Re: A request by Bobby Schilling, dba Building R Values LLC for approval of Preliminary Plat of Mt Carmel Addition, a proposed four (4) lot residential subdivision, located west of Great River Road and adjacent to Olethea Golf Course located in part of the SW¹/₄ Section 14 of LeClaire Township.

PLANNING & ZONING COMMISSION
STAFF REPORT
November 17, 2015

Request: Preliminary Plat approval of a four (4) lot residential major plat

R E S O L U T I O N
SCOTT COUNTY BOARD OF SUPERVISORS
DECEMBER 3, 2015
APPROVING PRELIMINARY PLAT OF MT CARMEL ADDITION

Preliminary Plat Review

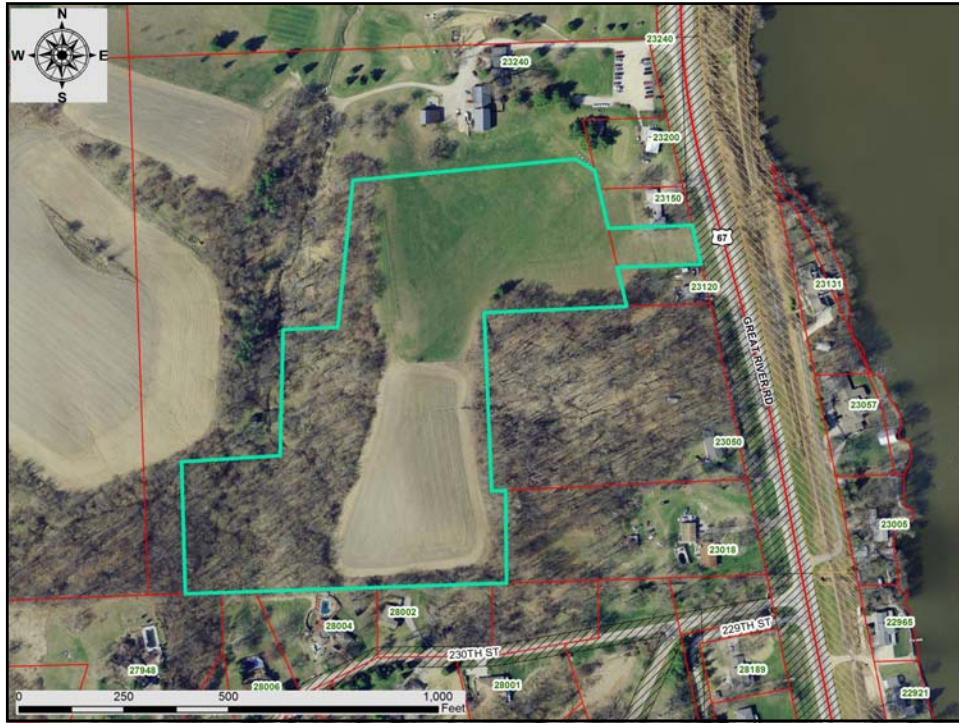
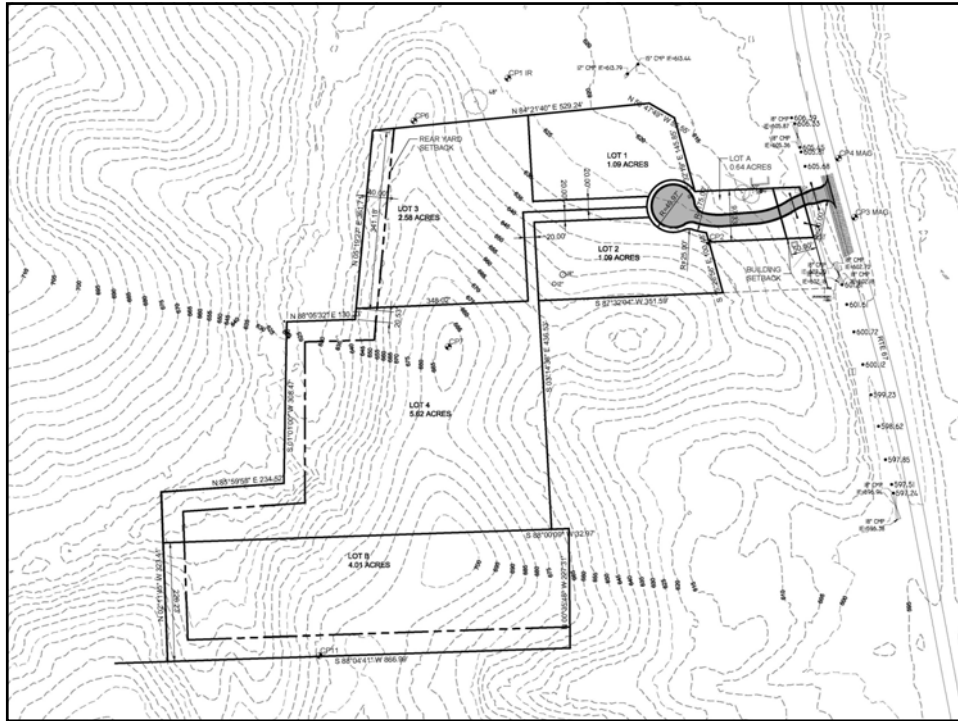
The plat shows a forty foot setback line which is unnecessary and somewhat inaccurate. Staff recommends that the setback restriction on the plat be removed. Setbacks are subject to zoning review at the time building permits are issued. Staff also recommends that the status of Lot B as an Outlot clearly be stated on the Plat. It has no access and can not be developed.

- All 4 proposed lots conform to the dimension and sizing requirements of the zoning and subdivision ordinances.
- Each lot will be served by private driveway coming off the cul de sac turnaround bulb. Lot 3 & 4 may have a shared drive for the initial 200+ feet of length.

- Staff recommends **approval** of the preliminary plat with the following conditions:
1. The notation on rear yard setbacks be removed from the Final Plat
 2. That a note be placed on the plat regarding Outlot B that it carries no right for separate development and that no building permits will be issued due to lack of access;
 3. A covenant shall be prepared and filed along with the Final Plat prohibiting any future re-subdivision of these 4 lots for further residential development; and
 4. A road maintenance agreement shall be prepared and filed along with the Final Plat creating a legal mechanism for continual maintenance of the shared access road.
